The Sandstone Precinct: MOD 7 Design Report

Document Number
SP-RPT-E-MAKE-0005

MOD 7 Design Report

Change of use: External tenancy

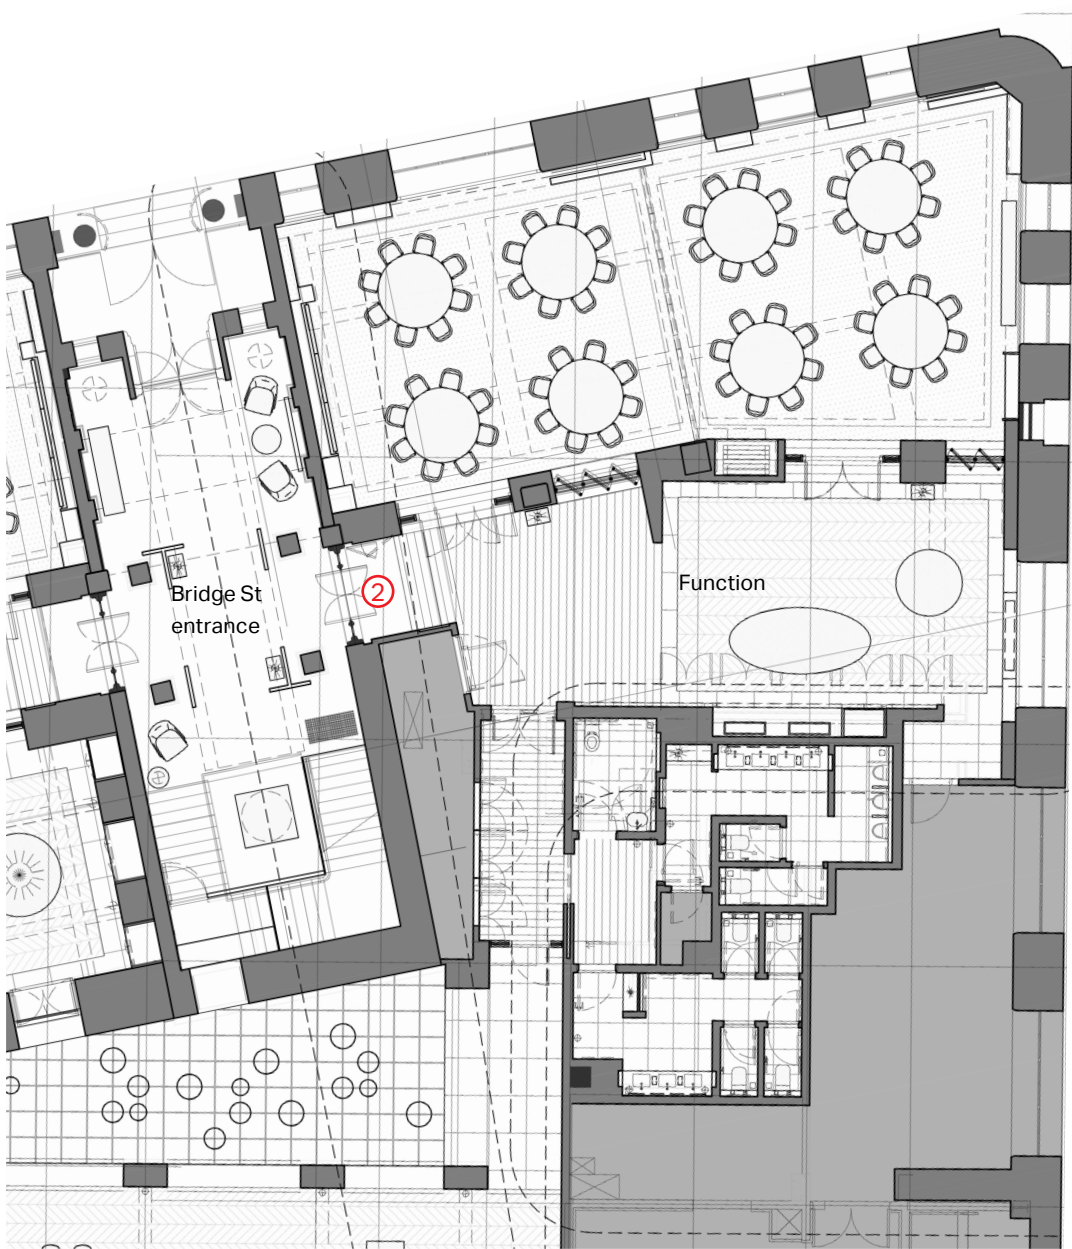
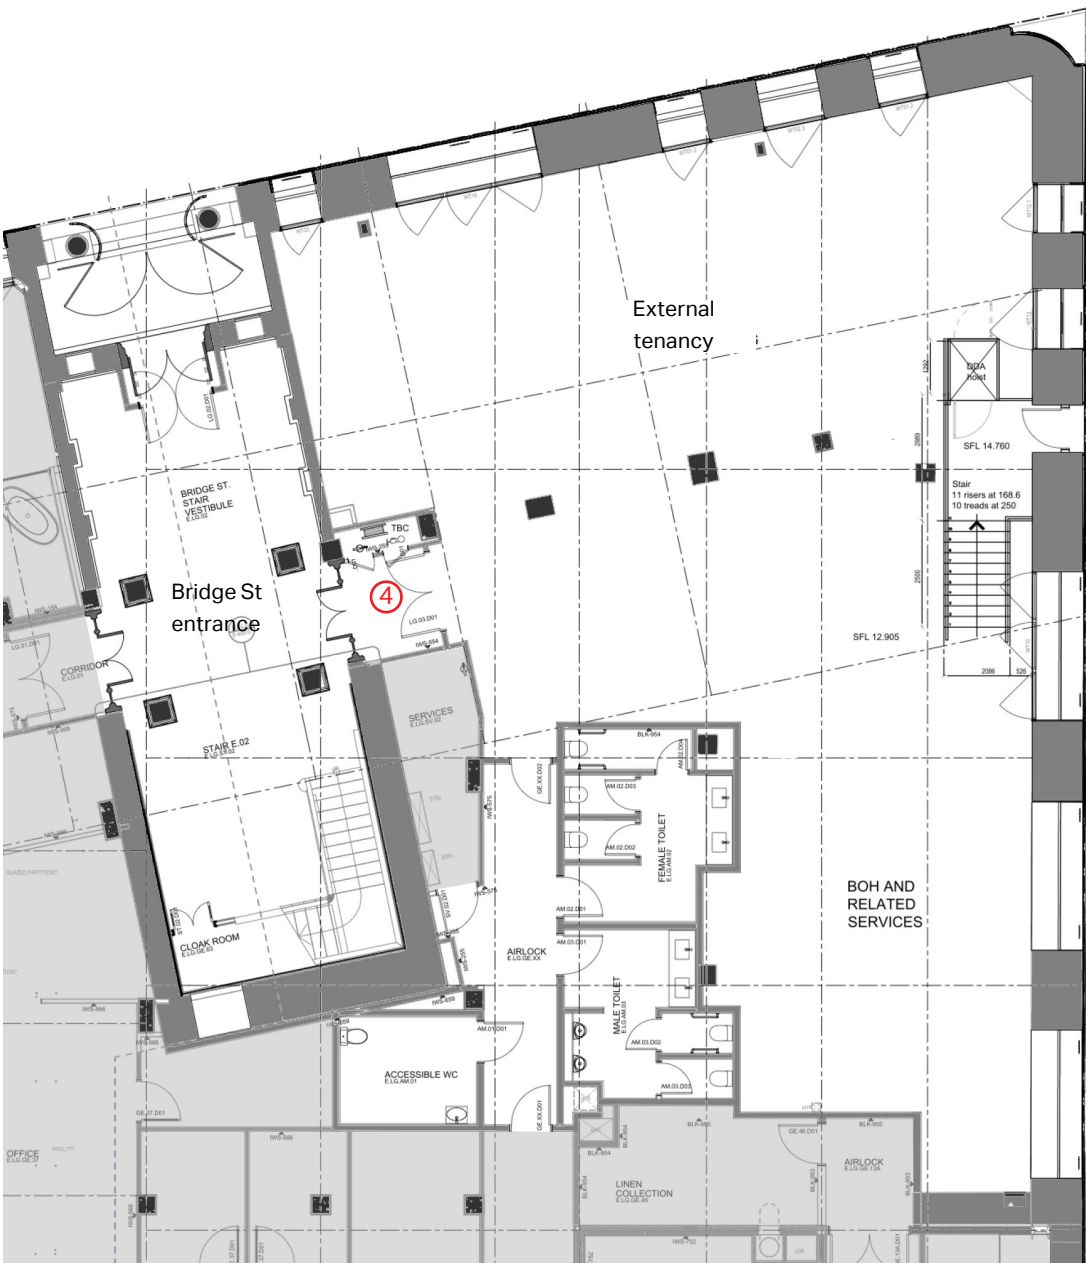
- 1. Existing heritage door locked off. From inside the function space, the opening is blocked out.
- 2. Entry to function through Bridge Street heritage vestibule. DDA access through Loftus Street laneway and guest room corridor

- 3. Existing heritage door reinstated to become DDA entrance into external tenancy. New lift and stair added to resolve level difference between street and tenancy.
- 4. Primary entrance to external tenancy through Bridge Street heritage vestibule

Guest rooms at lower ground

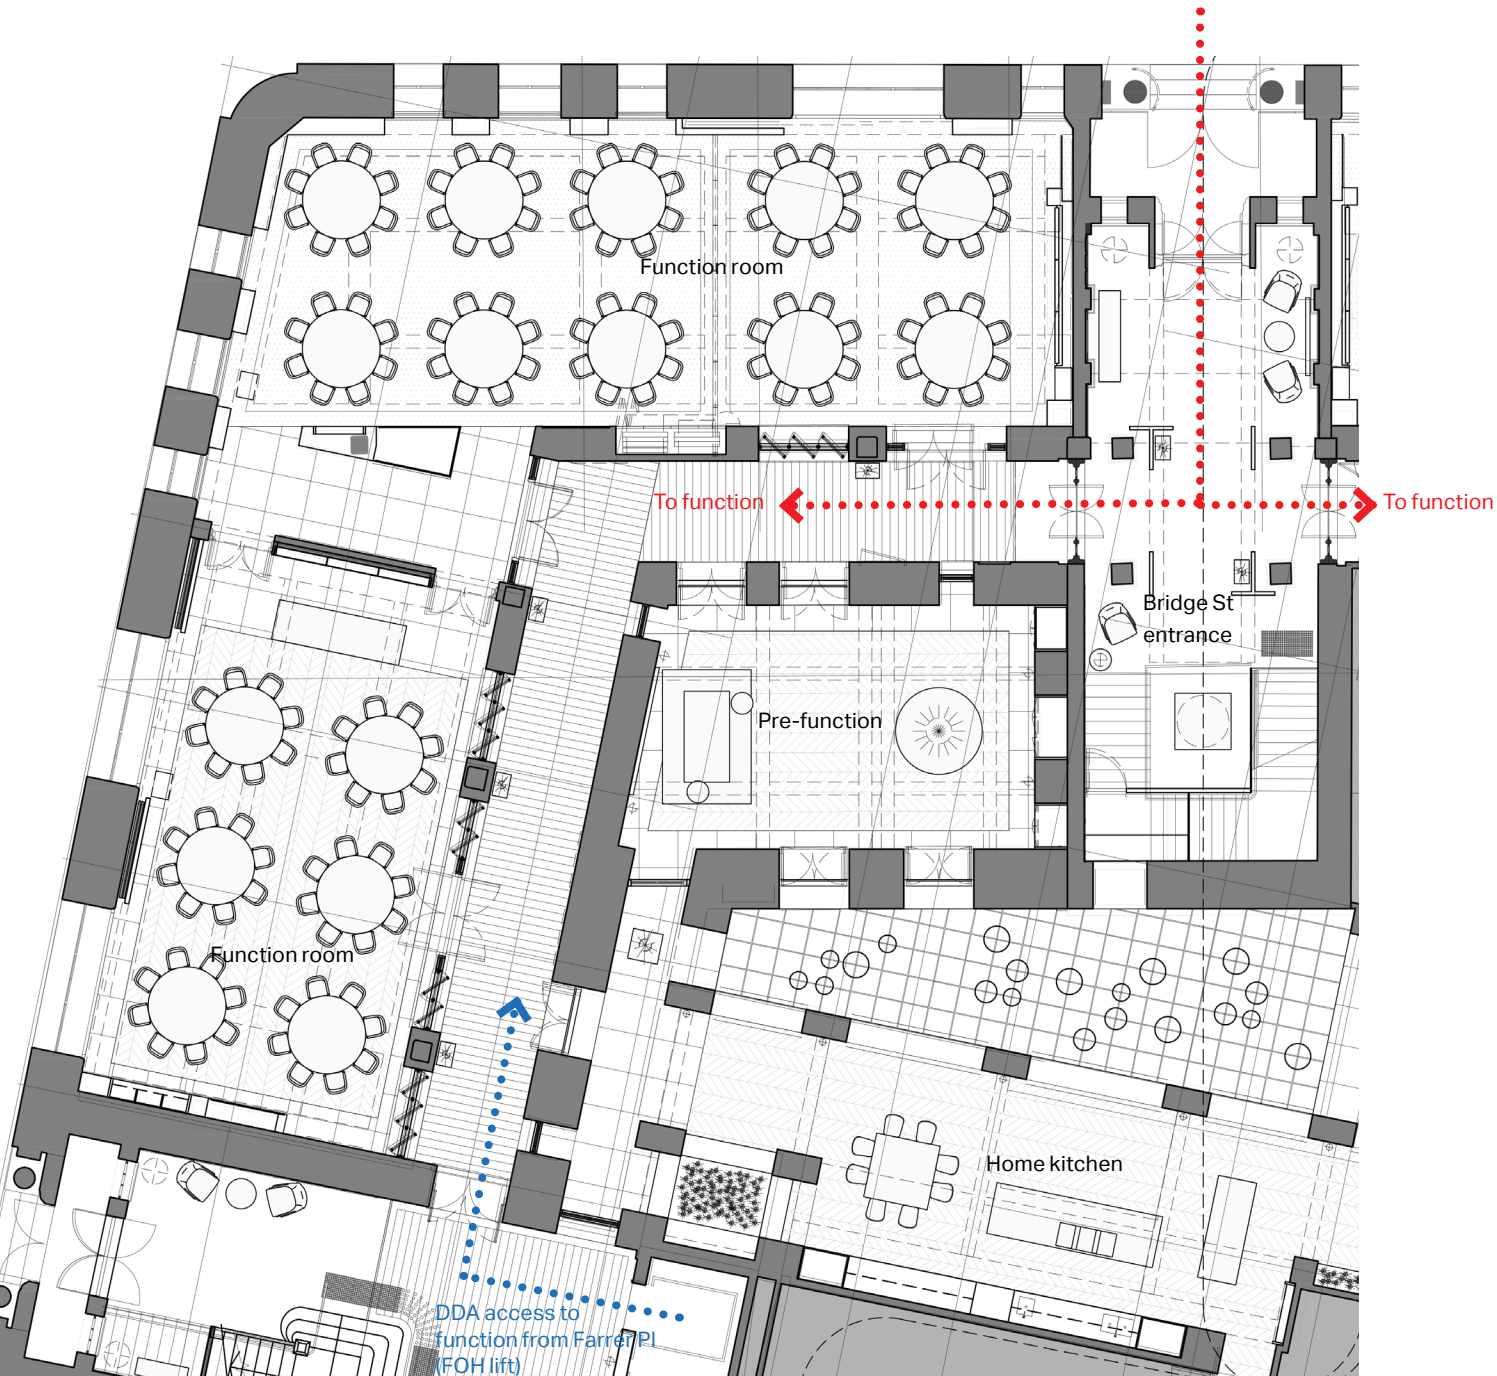
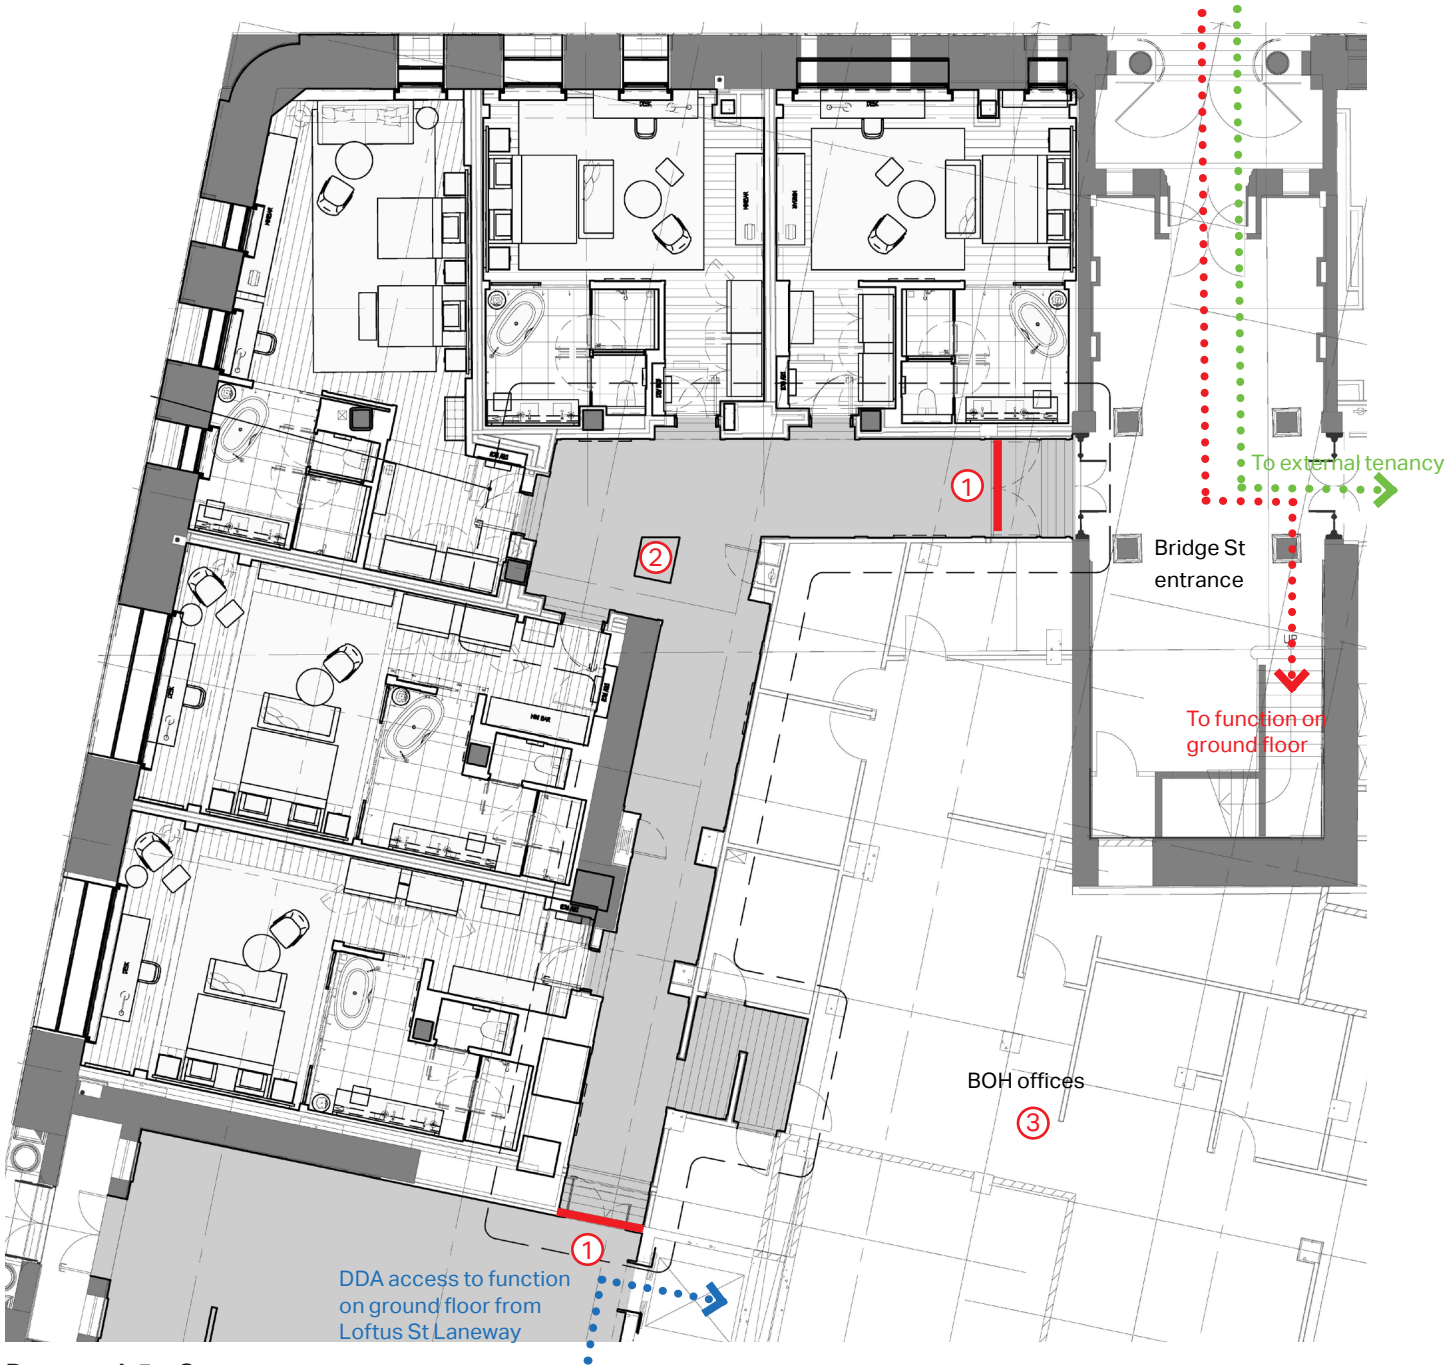
- 1. New solid timber doors to provide visual privacy between heritage vestibules and guest room corridor.
- 2. Guest room corridor accessed via key card by hotel guests only.
- 3. Home kitchen function space replaced with BOH hotel offices (moved over from the Lands Building)

Proposed pool design

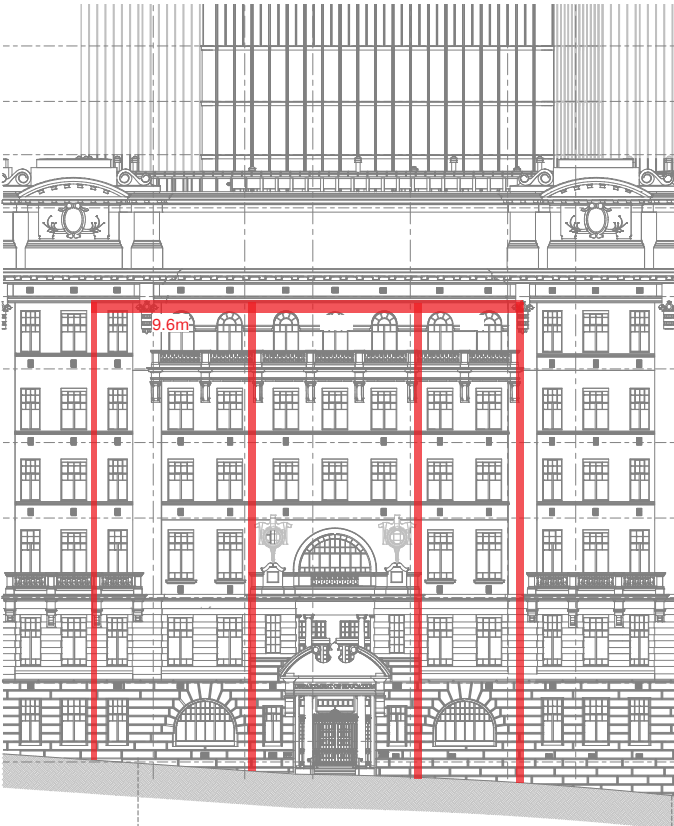
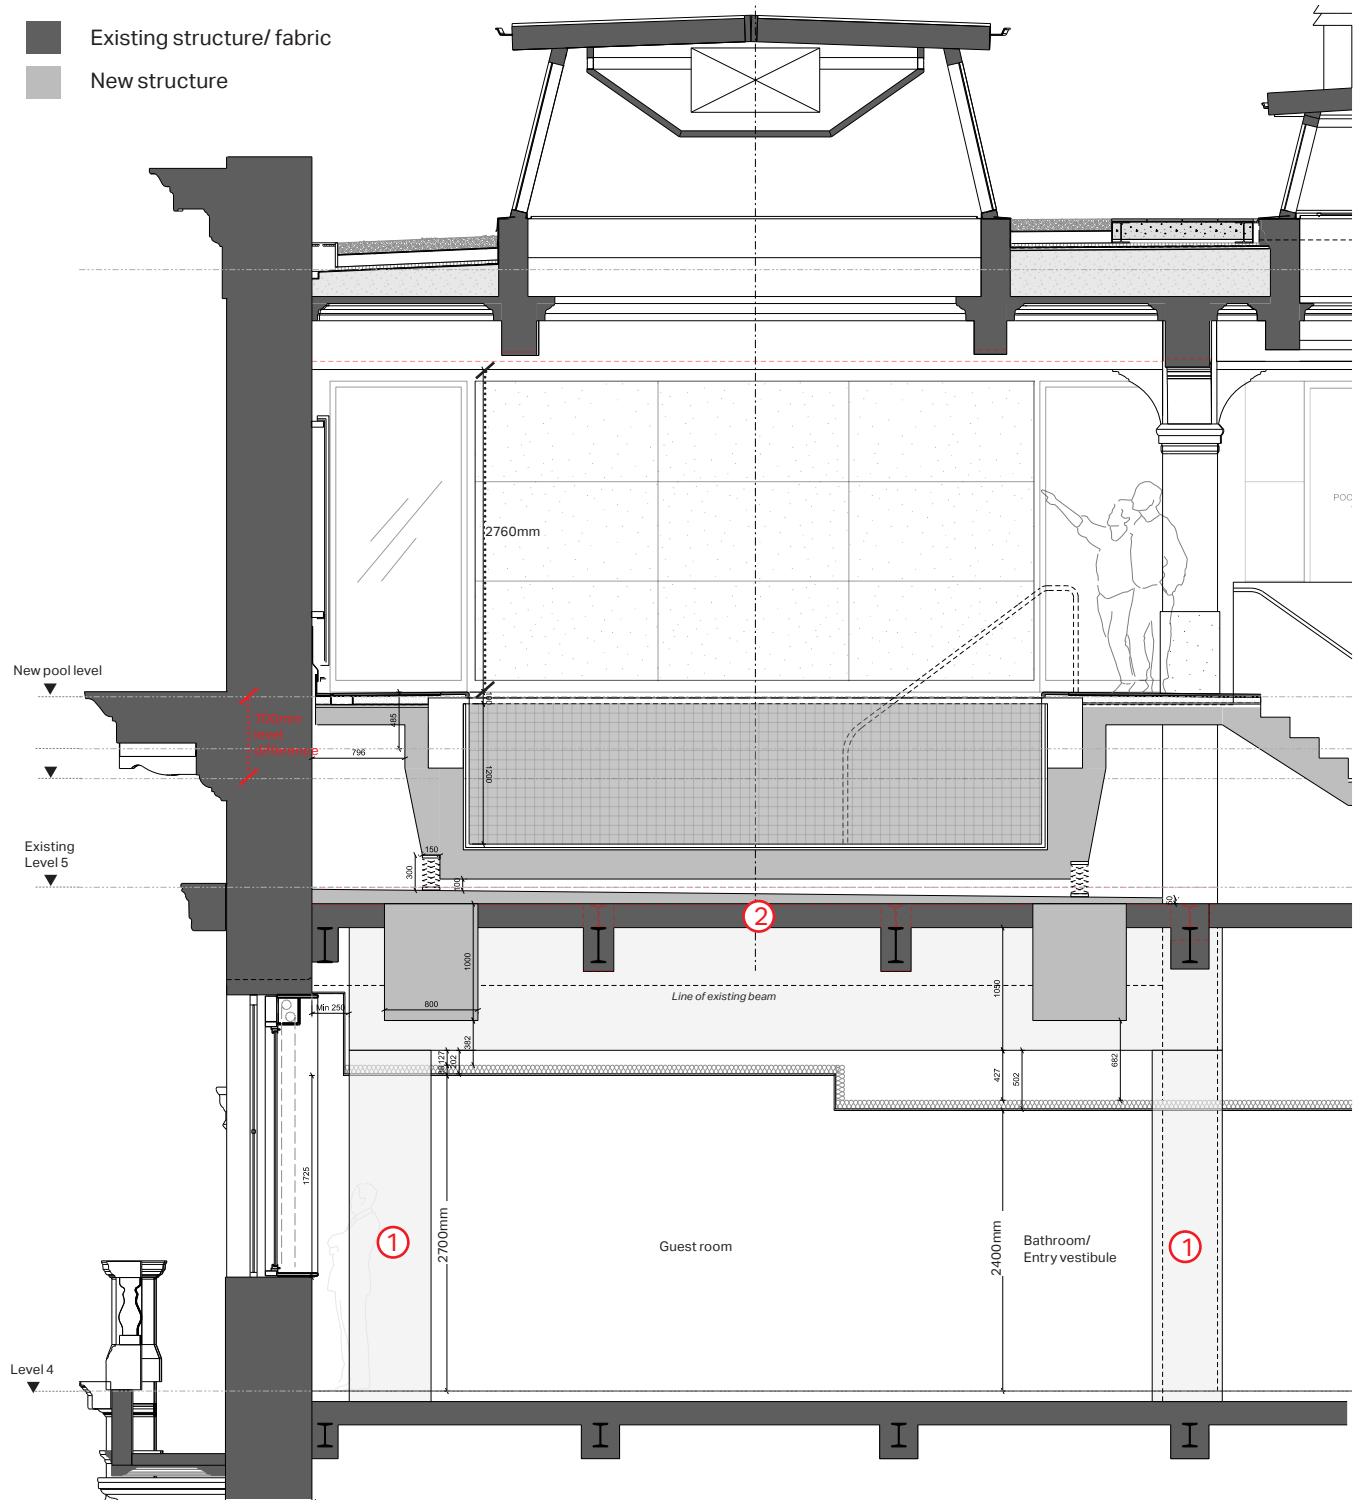
1. Recent site investigations have revealed that the existing wall construction is not strong enough to support the pool as previously proposed. Previous strengthening works and cracking to the stonework has been uncovered (see above). Therefore 8 new columns on levels LG-4 are required to support the new pool beams.
2. TTW Structures have advised that the demolition of the level 5 slab in the north will create a significant structural risk therefore have recommended the existing slab is retained in place. This raises the pool level by circa 445mm to accommodate the new pool structure above existing retained slab.

- The pool is self-supporting and does not rely on strengthening existing columns or existing footings. As a result this scheme eliminates the need to strengthen the existing heritage marble columns on ground and lower ground floor
- Footings are conventional and relatively straight forward. New footing zones avoid heritage areas (notably the marble floor in Bridge Street stair lobby)
- Self supporting pool removes the additional pool loading from the existing façade and reduces the risk of cracking.
- Less risk regarding any unknown or unforeseen items in the existing building structure
- The concrete pool solution is a trusted methodology in the Australia market.
